**Attachment 9**  
**NRC3-12-0003**  
(17 pages)

**Response to RAI Letter No. 70**  
**(eRAI Tracking No. 6244)**

**RAI Question No. 03.07.01-7**

**Response to RAI Letter No. 70**  
**(eRAI Tracking No. 6244)**

Figure 8: CB horizontal estimated 2% damped FIRS compared to the 2% damped spectrum for the CB H1 SSI time history.

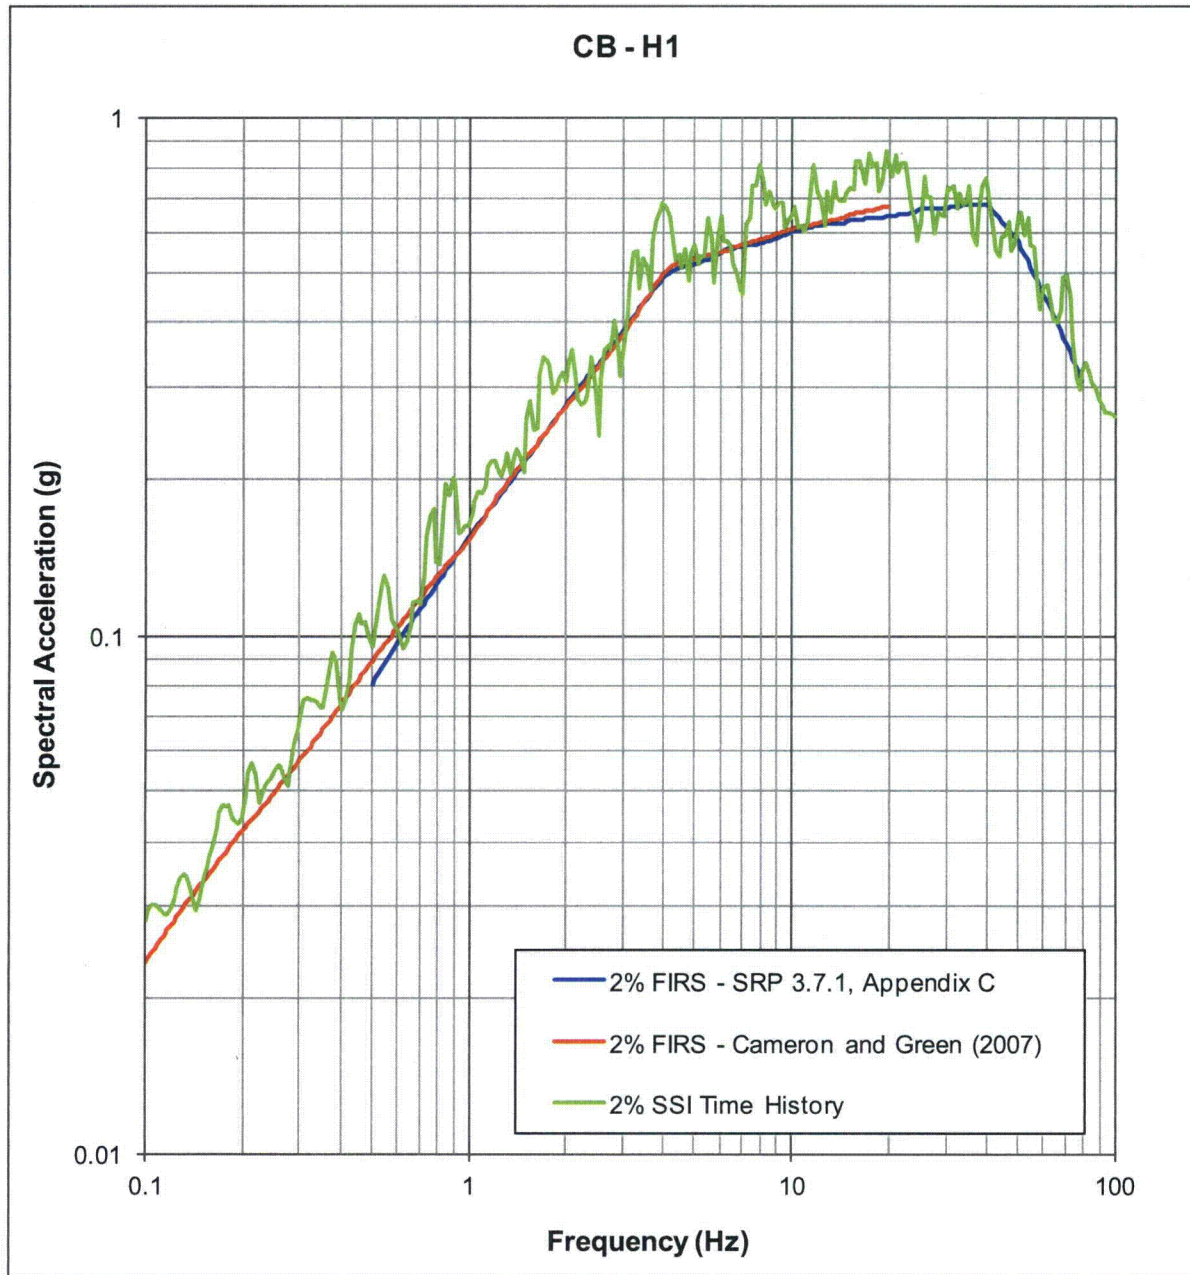
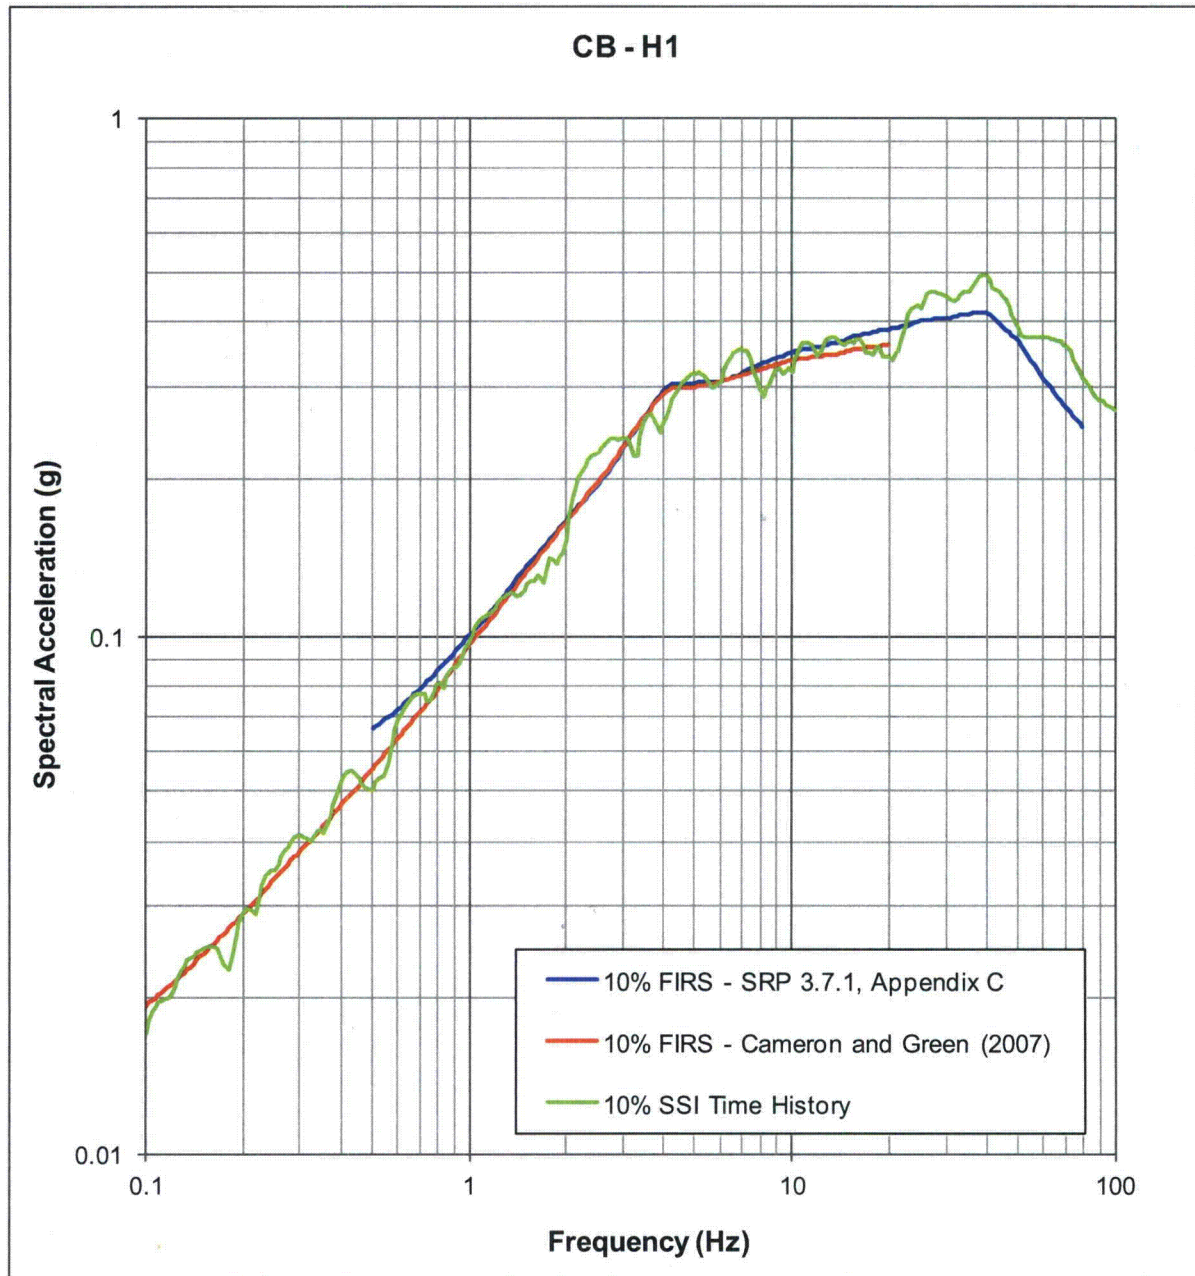
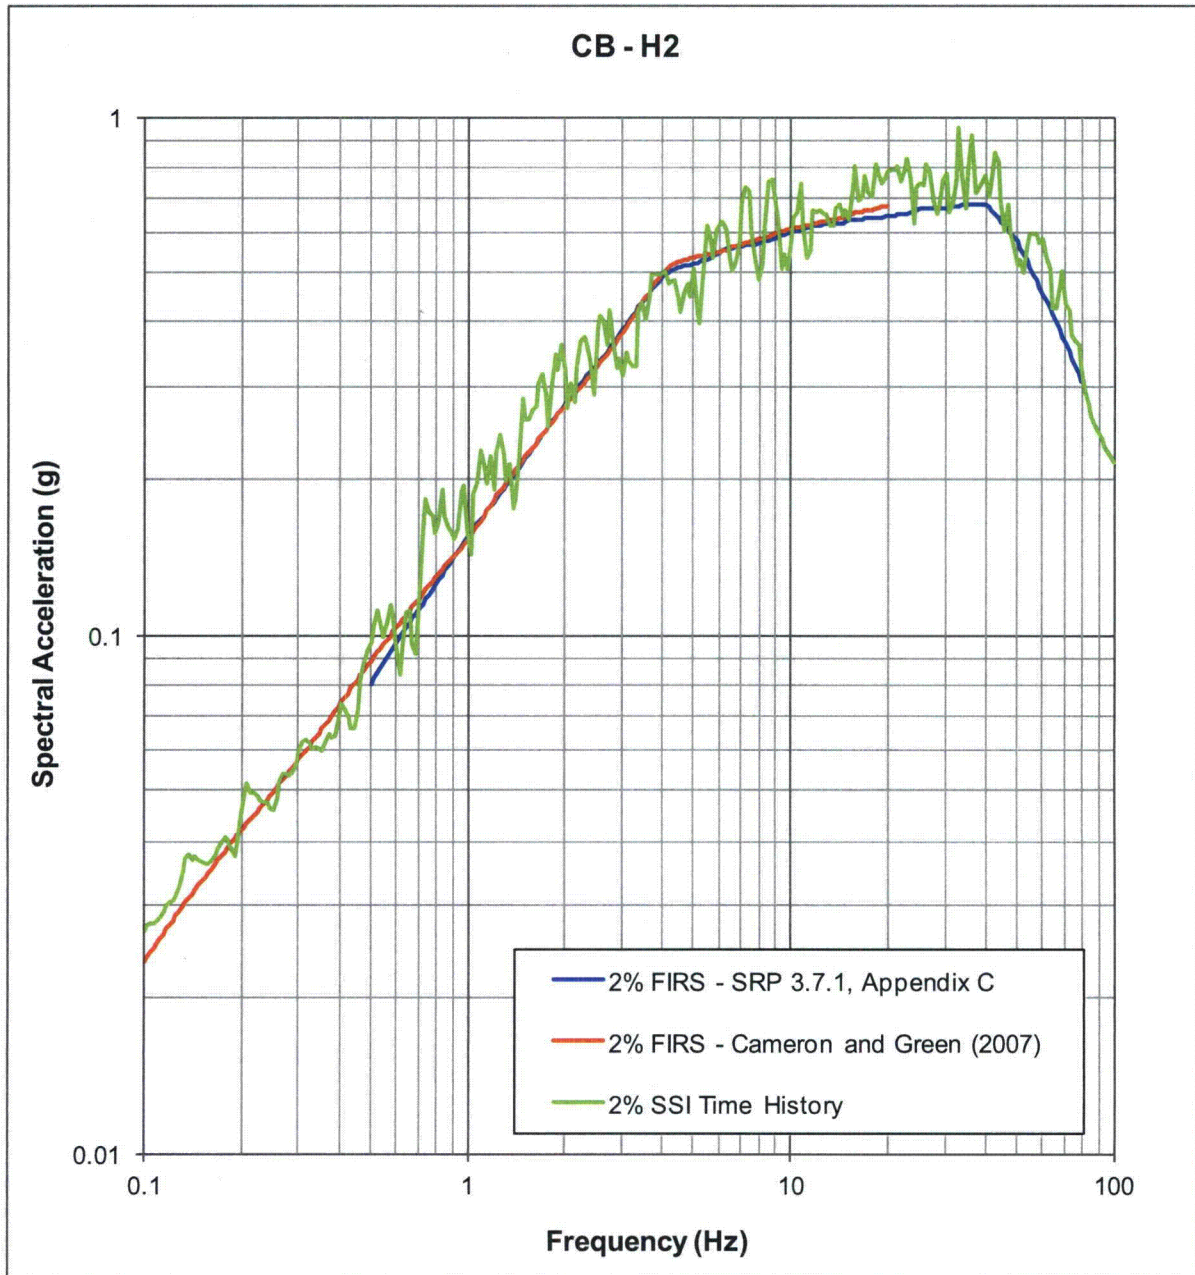
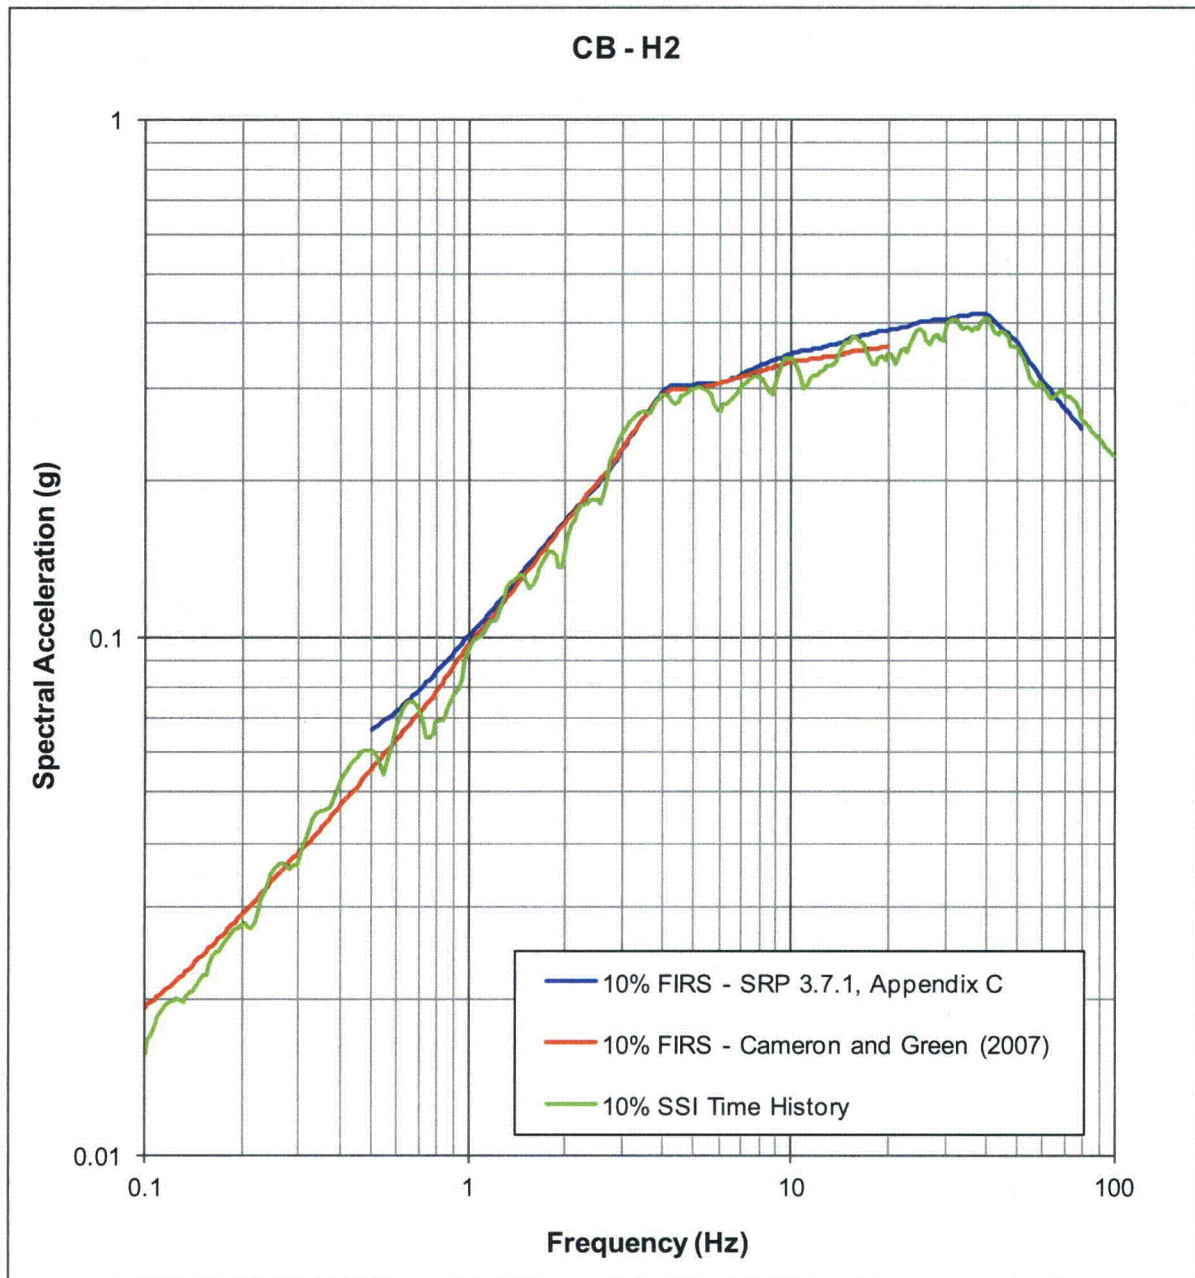
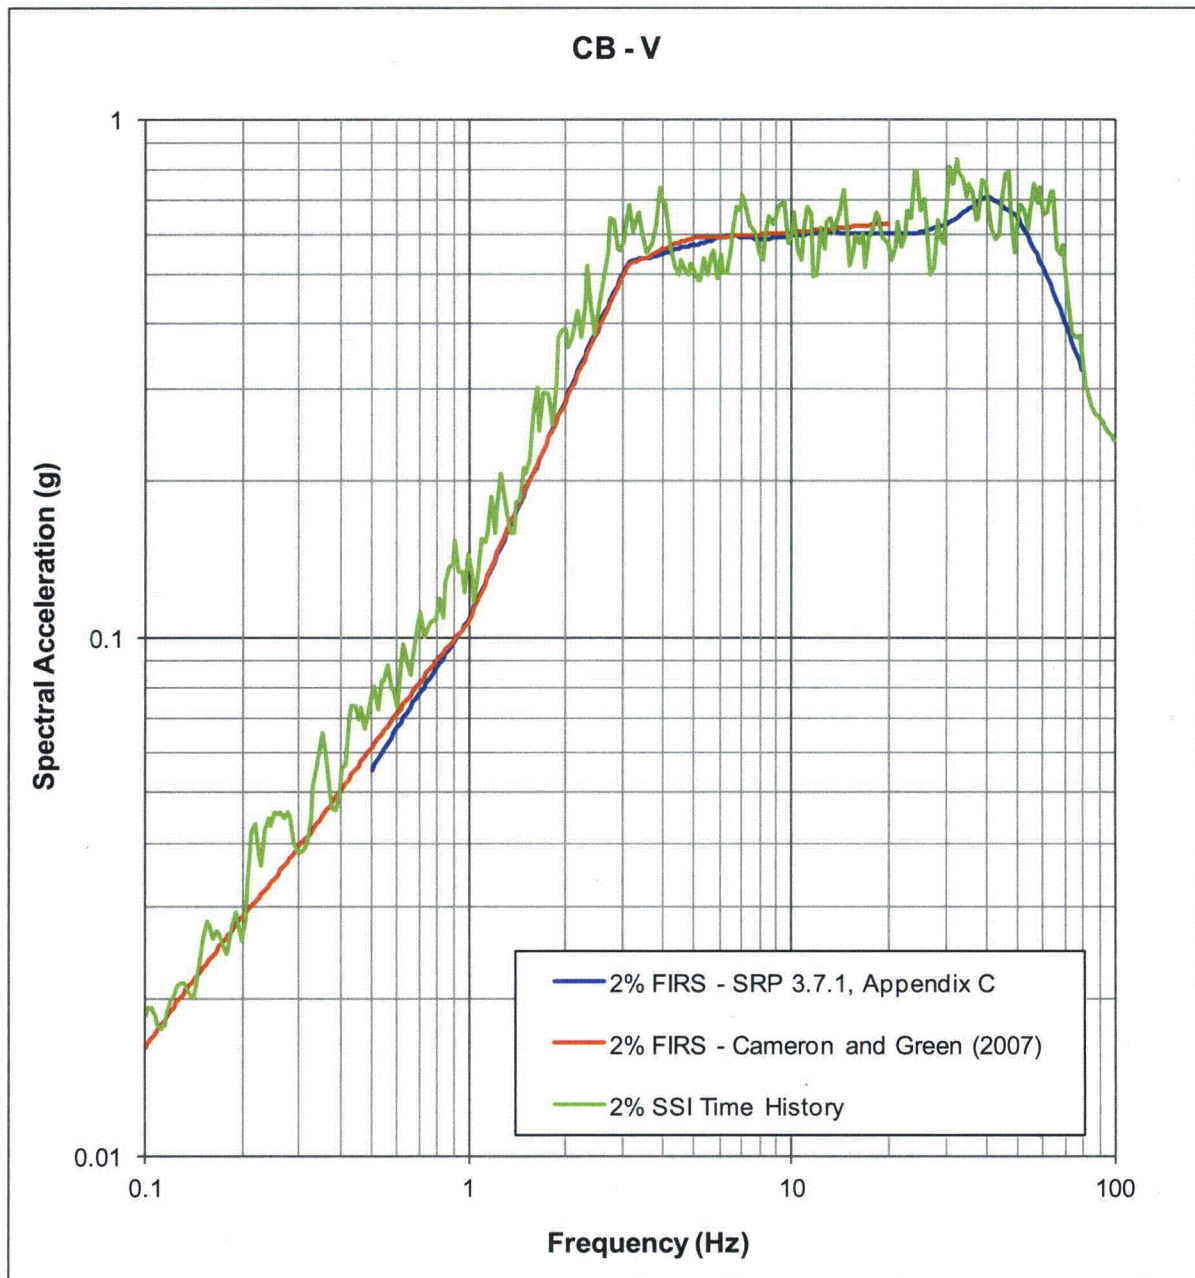
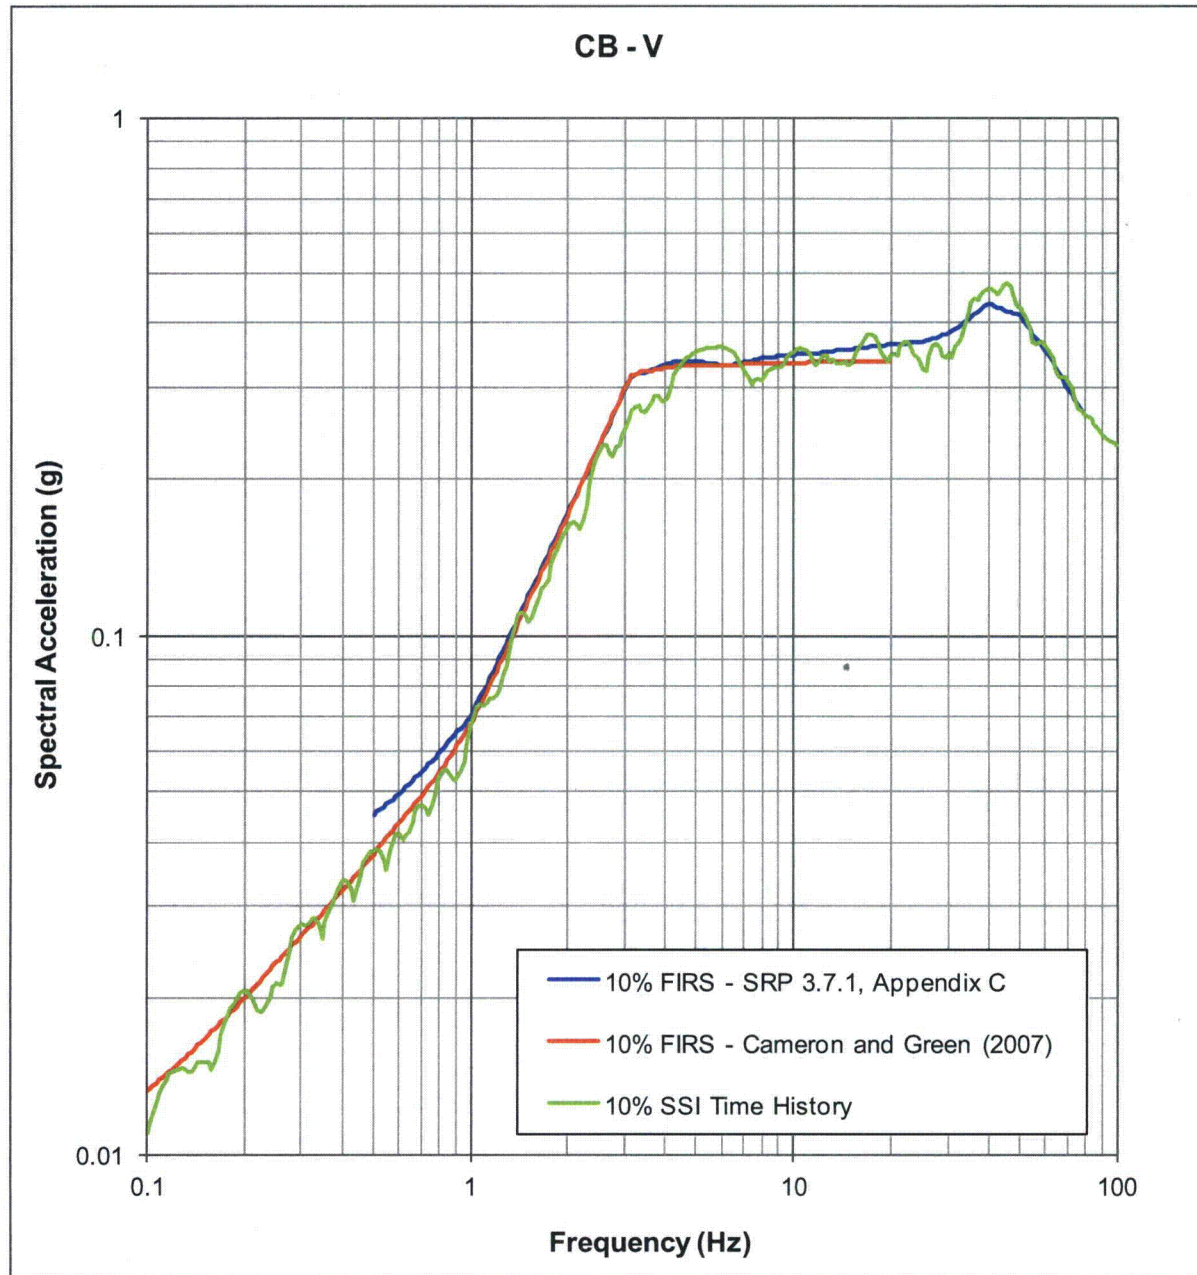
*SRP Acceptance Criteria 3.7.1.II.1B also specifies that PGV/PGA should be consistent with the characteristic values for the controlling earthquake. As such, the applicant is requested to provide further justification of the acceptability of the PGV/PGA values for the artificial time histories being higher than the selected controlling earthquake. The applicant is also requested to provide comparison of the response spectra of the artificial time histories and the estimated target spectra (SSI FIRS) at 2 percent and 10 percent damping values for RB/FB and CB.*

Figures 2 through 13 show the RB/FB and CB SSI FIRS scaled to 2 percent damping and 10 percent damping. Shown on each of the plots is the corresponding 2 percent or 10 percent damped spectrum for an individual SSI time history. The time history spectra are in good agreement with the scaled FIRS.

Figure 1: Comparison of Fermi 3 RB/FB and CB SSI FIRS with the NUREG/CR-0098 median rock spectral shape and enveloping NUREG/CR-6728 CEUS spectral shape, both scaled to a minimum PGA of 0.1g. All spectra are for 5% damping.

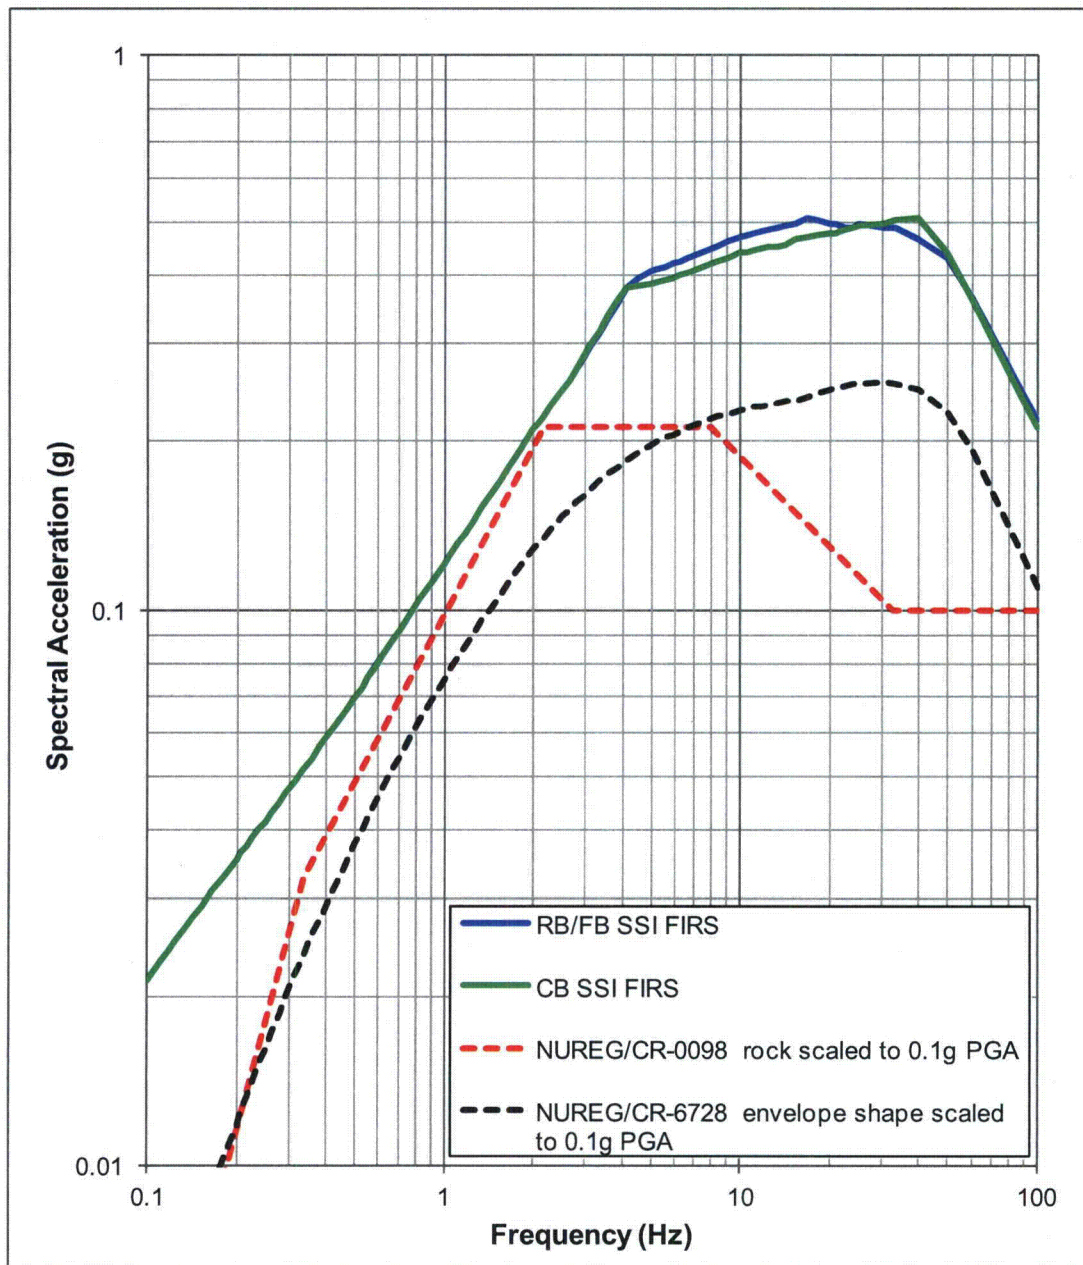
*However, the guidance in SRP 3.7.1 and ISG-017 also indicates that, to satisfy the regulatory requirements, the minimum horizontal PGA of 0.1g should correspond to a smooth broad-band spectral shape such as the one described in RG 1.60. Therefore, the applicant is requested to provide in the FSAR comparison plots of the RB/FB and CB horizontal FIRS with the RG 1.60 horizontal spectrum anchored at 0.1 g, which demonstrate that the RB/FB and CB horizontal FIRS envelope the RG 1.60 spectrum at all frequencies of interest. The staff needs this information to confirm that the site-specific seismic input used in the site-specific SSI analysis meets 10 CFR Part 50, Appendix S.*

The Regulatory Guide (RG) 1.60 spectral shape was derived from statistical analyses of strong motion records obtained primarily at deep soil sites in the western United States (NUREG/CR-6926, Section 3.1). As the Fermi 3 RB/FB and CB are to be founded on relatively hard rock (Bass Islands Group with a shear wave velocity of 6,650 fps [2027 m/s]) in the central and eastern United States (CEUS), the RG 1.60 spectral shape is not considered appropriate. At a minimum, a rock site spectral shape should be considered. For example, NUREG-1407 (Chen et al., 1991) utilized the median response spectral shape for rock sites developed in NUREG/CR-0098 (Newmark and Hall, 1978) to characterize ground motions for CEUS nuclear power plants founded on rock. Figure 1 shows that the median NUREG/CR-0098 response spectral shape for rock sites scaled to 0.1g PGA is enveloped by the Fermi 3 SSI FIRS.
